Land Use File(s): VR-13-02, NR-13-08

## NOTICE OF DECISION

**Applicants:** Greg and Shirlene McGowan  
**Location:** 4915 SE Brookside Dr  
**Tax Lot:** 1S2E30BD 01400  
**Application Type:** Type II Variance and Construction Management Plan Review  
**Decision:** Approved with Conditions  
**Review Criteria:** Milwaukie Zoning Ordinance:

**Construction Management Plan**  
Scale: 1/8" = 1'-0"

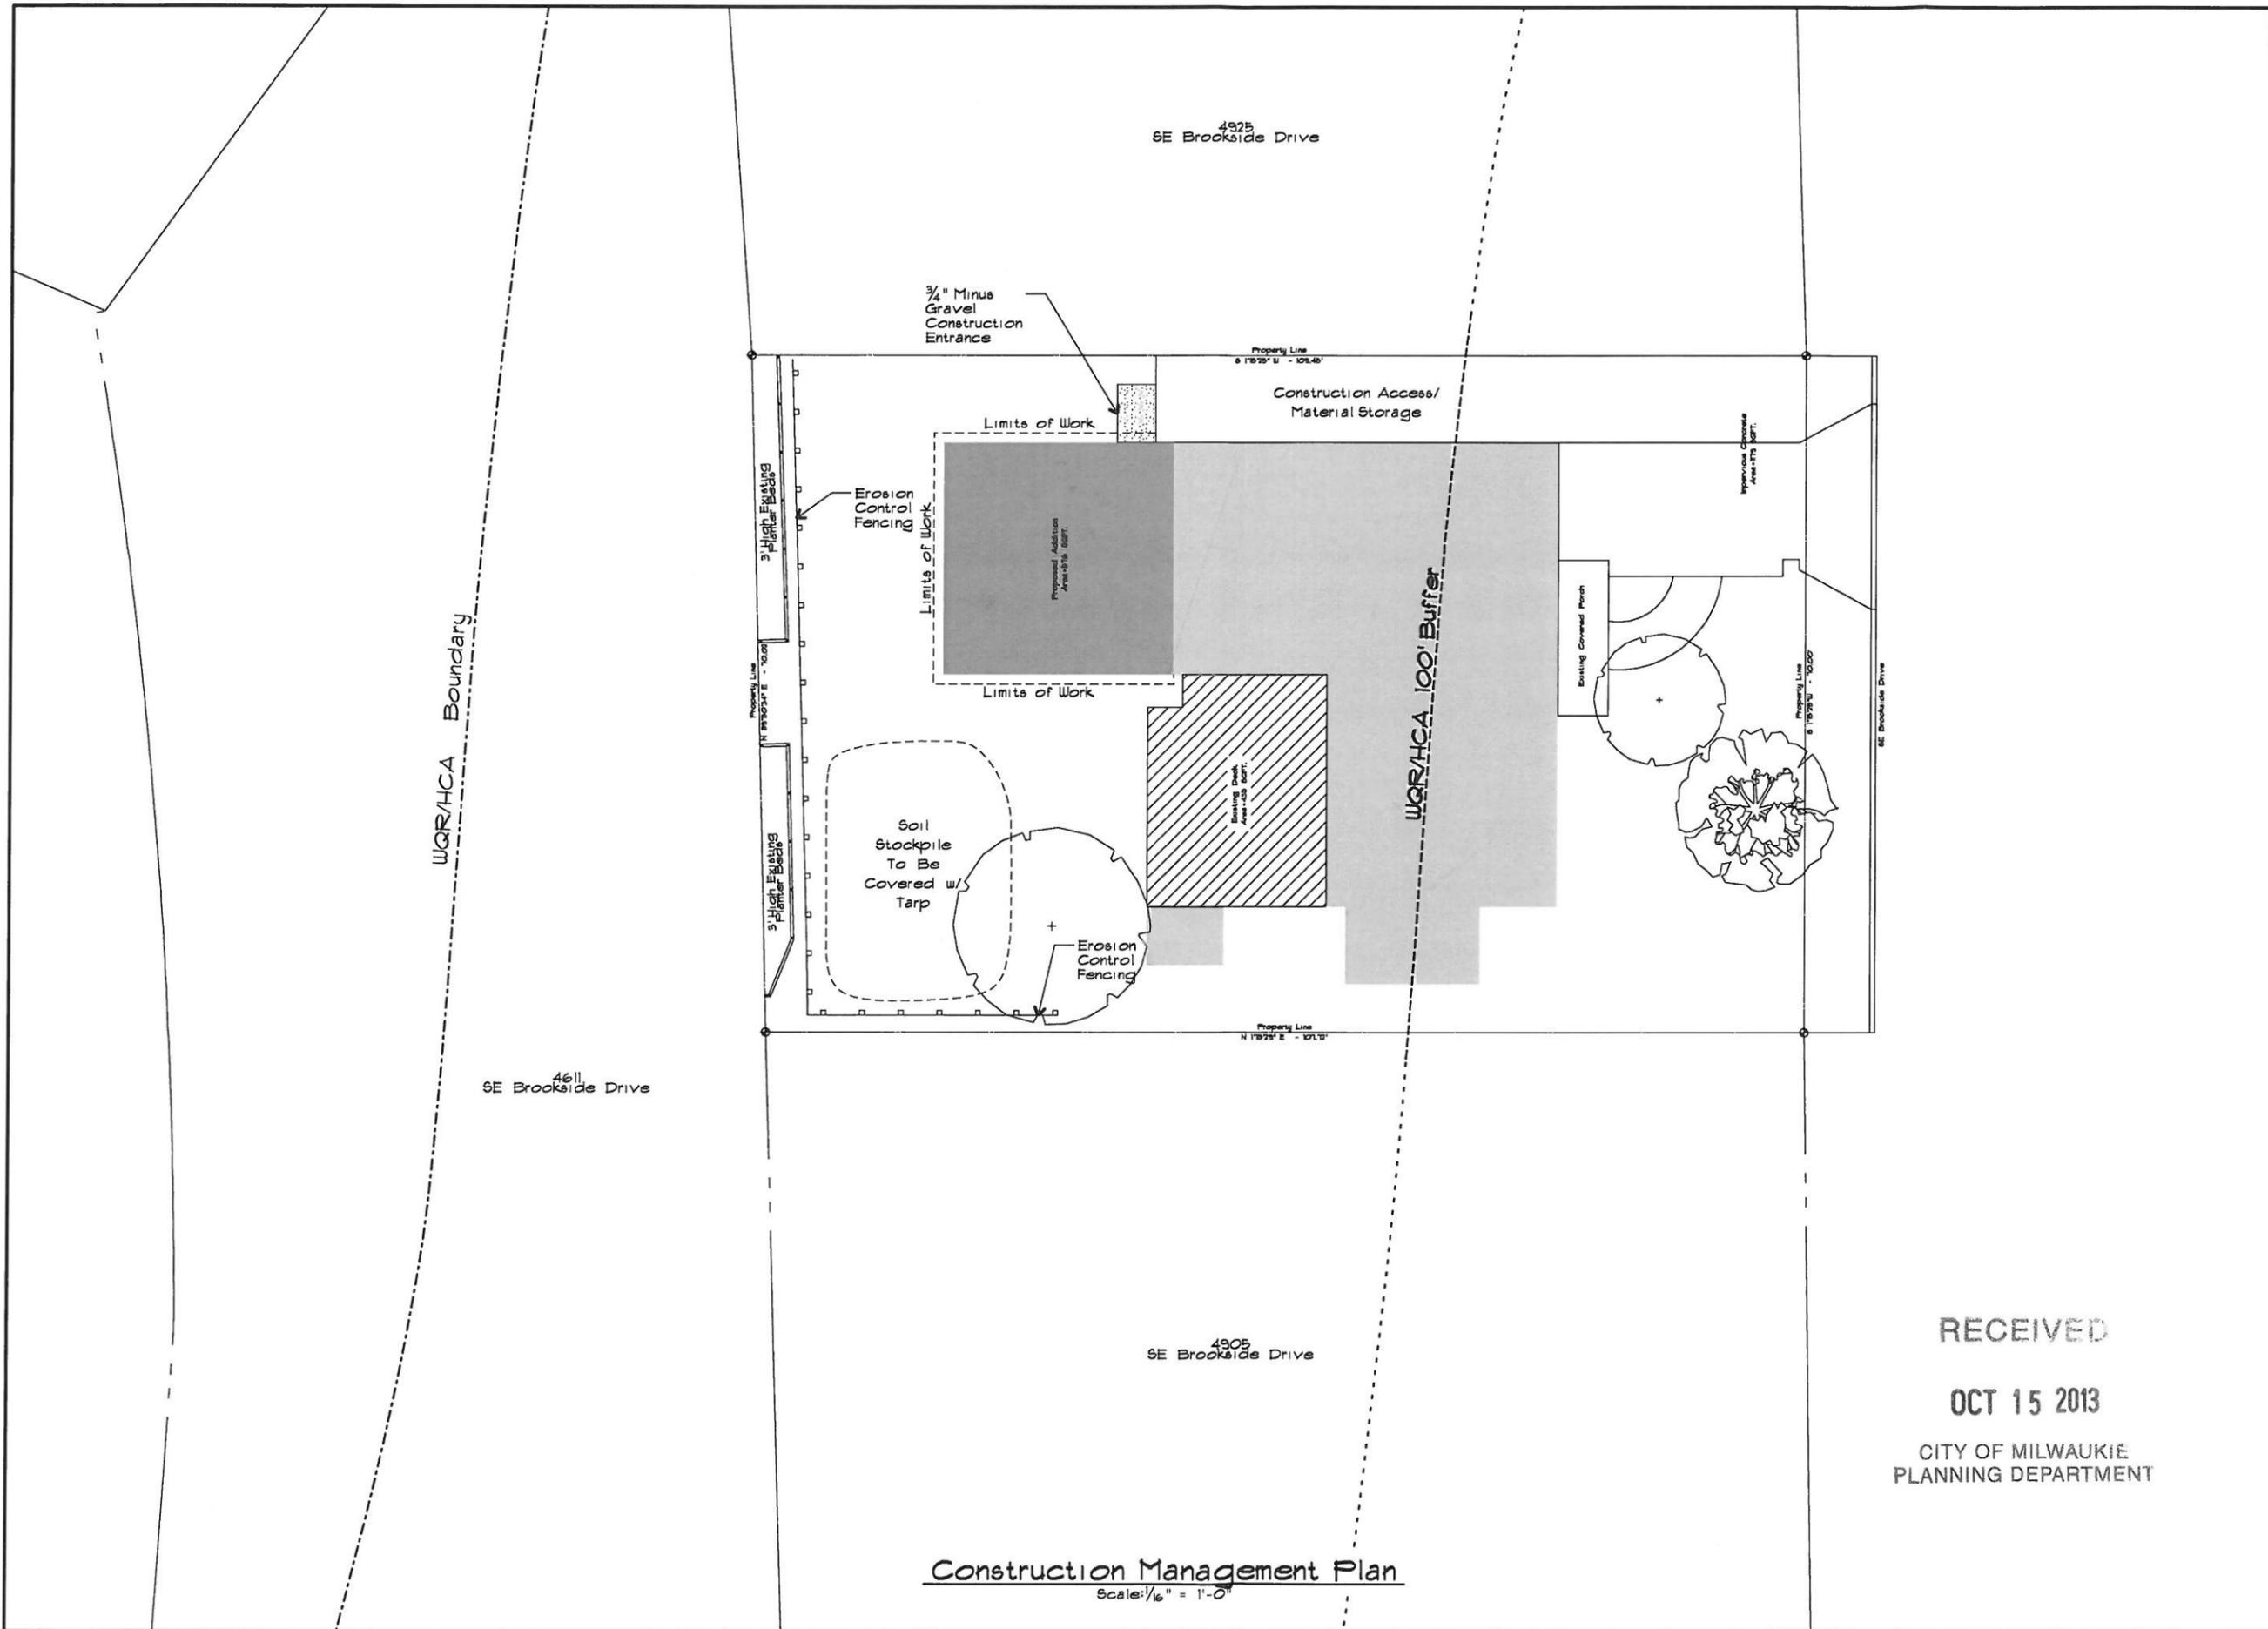
The applicant's submittal includes a site plan as well as a narrative description of the proposed activity. The submittal indicates that silt fencing will be installed between the northern property boundary and the project area and soil stockpile area to control erosion and avoid disturbance to the WQR and HCA features on the adjacent property to the north. The flat topography of the site, the existence of hedges and fences along the eastern and western property boundaries, two existing raised planter beds between the project area and the northern property boundary, and the proposed silt fencing all function to limit the potential for erosion impacts to the nearby WQR and HCA area.

The requirement to provide a construction management plan, with sufficient information to demonstrate that the nearby WQR and HCA areas will not be impacted by the proposed activity, is met.

1. As part of the building permit submittal for the proposed development, the applicant shall submit the approved construction management plan (Exhibit 1-c) for final review by the City's erosion control specialist. If the City's erosion control specialist determines that additional elements must be added to the plan to adequately address erosion control issues associated with the proposed development, those final review comments from the City's erosion control specialist shall be incorporated into a revised construction management plan, which shall serve as the guide for inspections for the duration of the project.
